The Commission has issued the enclosed Amendment No. 60 to Facility Operating License No. DPR-43 for the Kewaunee Nuclear Power Plant. The amendment consists of changes to the Technical Specifications in response to your application transmitted by letter dated June 4, 1984 and as revised August 21, 1984. This action closes out our TAC Number 55221.

Amendment No. 60  
License No. DPR-43

SAFETY EVALUATION BY THE OFFICE OF NUCLEAR REACTOR REGULATION  
RELATED TO AMENDMENT NO. 60 TO FACILITY OPERATING LICENSE NO. DPR-43

KEWAUNEE NUCLEAR POWER PLANT

FIGURE TS 6.2-1

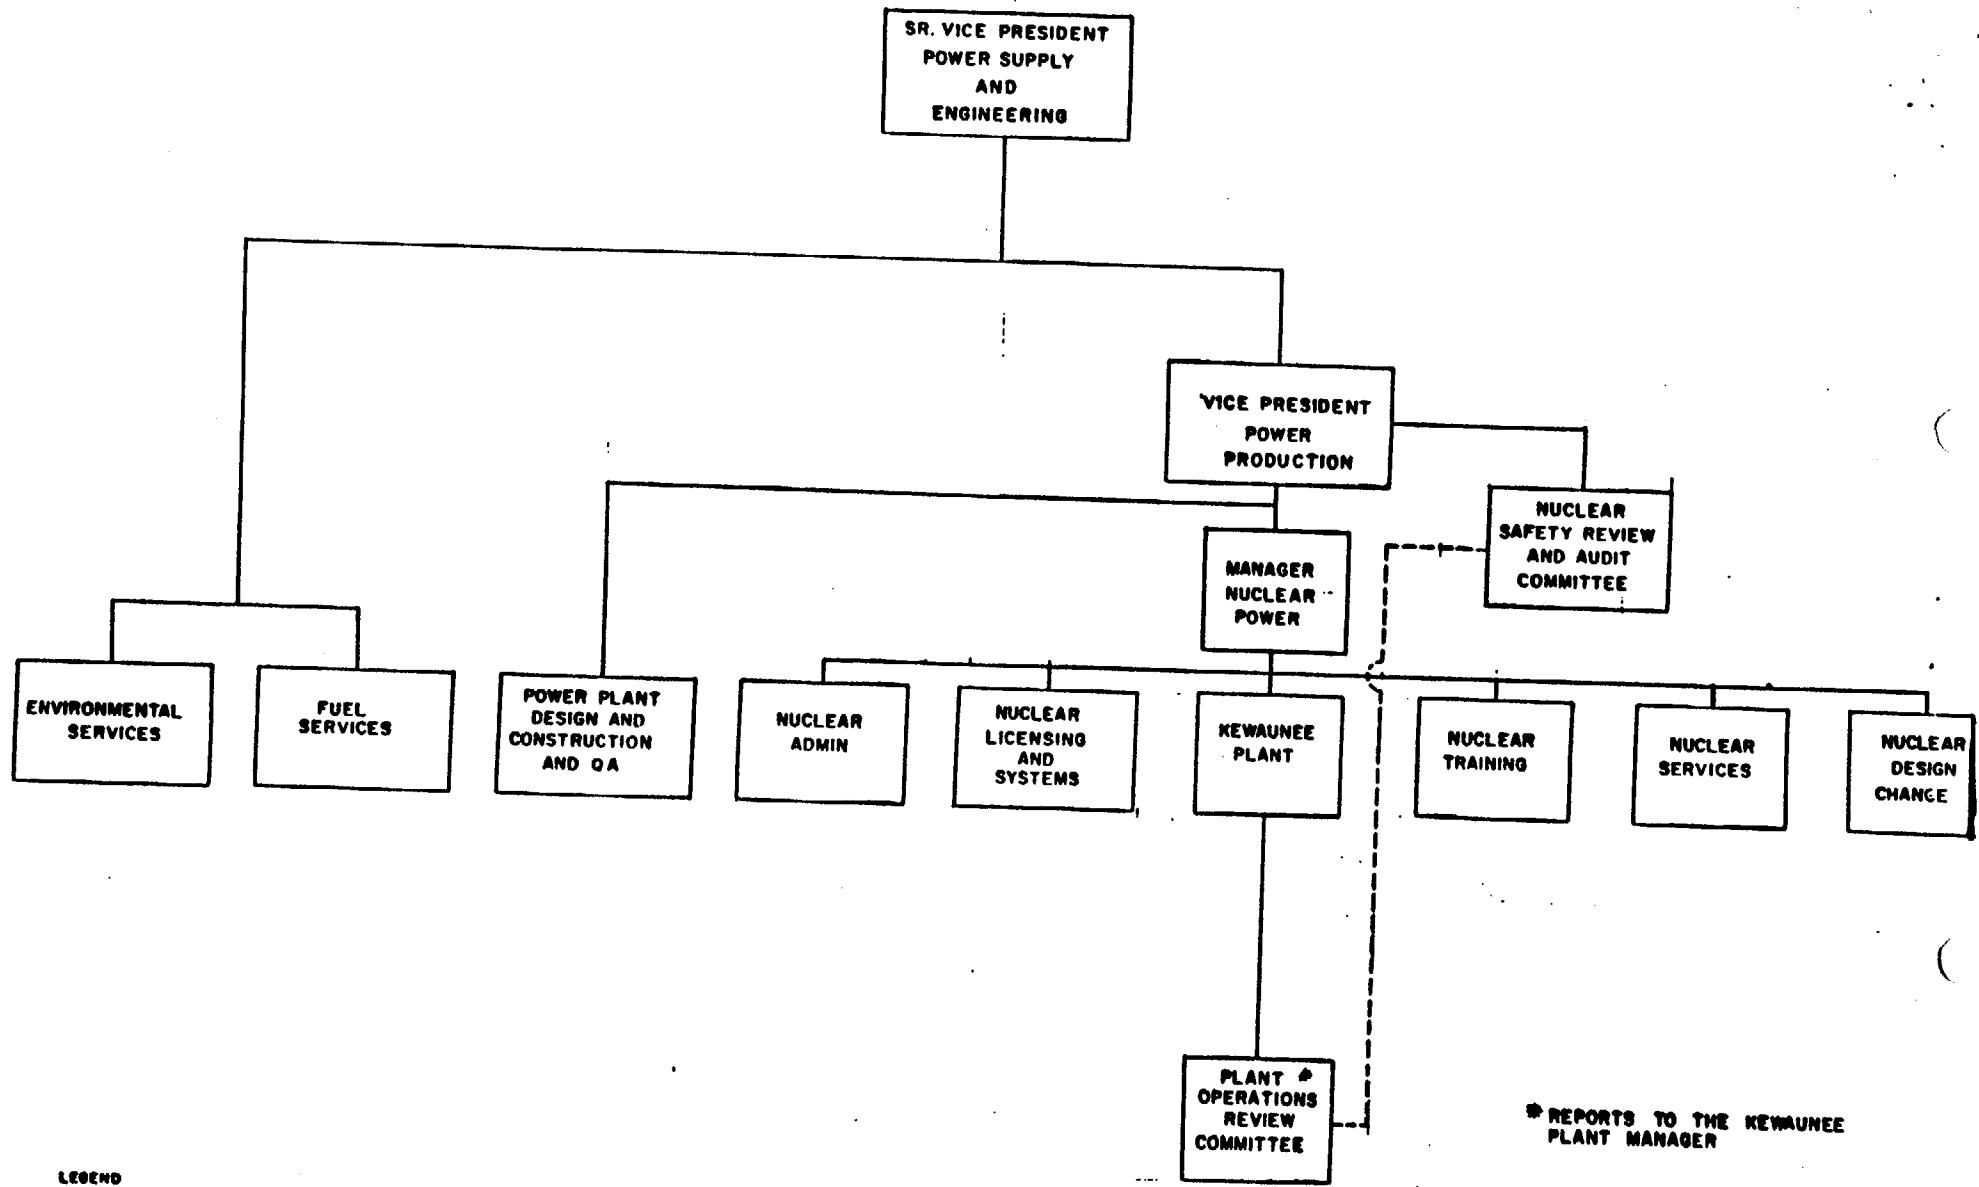
- B. Organization, Authority of Corporate and Facility Staff (pages 6-1, 6-2, 6-2a, 6-3, 6-7 and Table TS 6.2-1)

Figure TS 6.2-1 was modified to show the above title and organizational changes and also the title change of the Power Plant Design and Construction to include QA and the change in reportability from the Senior Vice President - Power Supply and Engineering to the Vice President - Power Production.

We have reviewed the above organizational and staffing changes and even though the Quality Assurance Group has been moved from reporting to the Senior Vice President - Power Supply and Engineering to the Vice President - Power Production, the group still remains at the same organization tier as the operating facility; therefore, the independence of the group is maintained. We find the above changes to be acceptable.

FIGURE TS 6.2-2

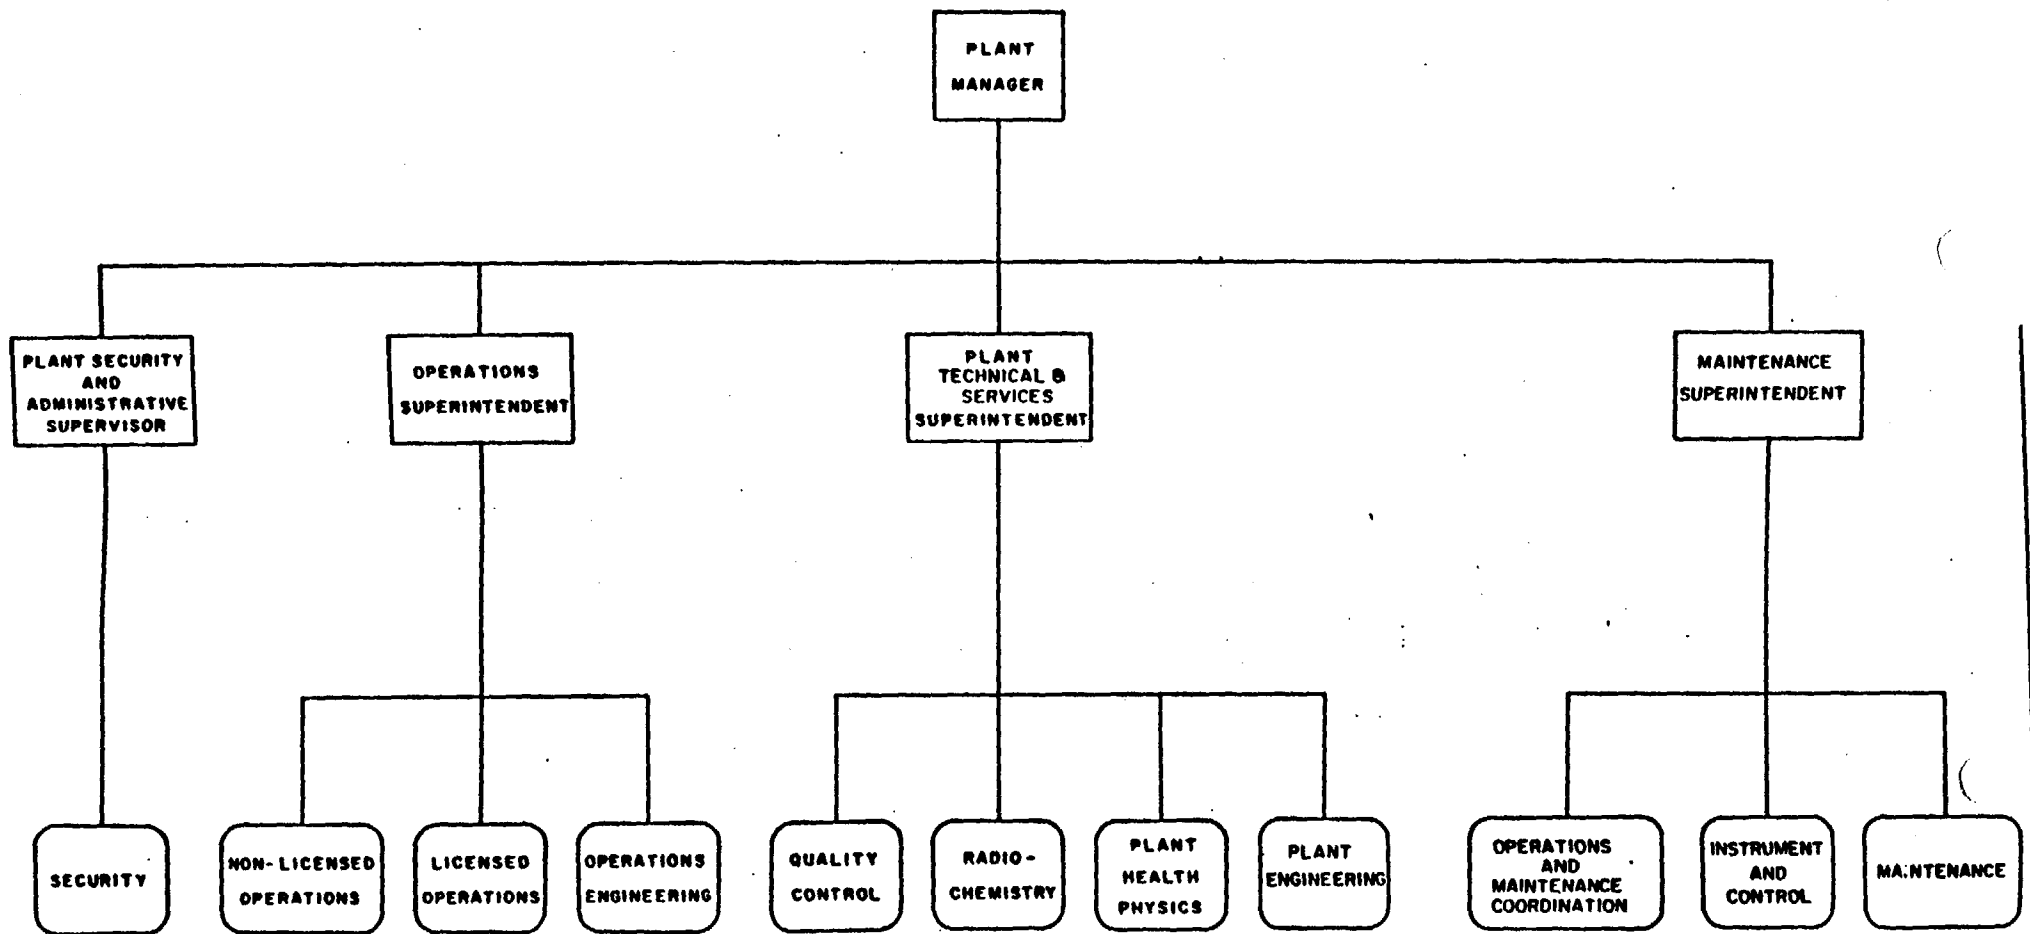
- A. Change of Title (pages 6-5, 6-7, 6-8, 6-11, and Tables TS 6.2-1 and 6.2-2)

This change is a change in title from the present Vice President - Nuclear Power to Vice President - Power Production. The duties and qualifications other than minor organizational changes remain the same; therefore, we find the change is acceptable.
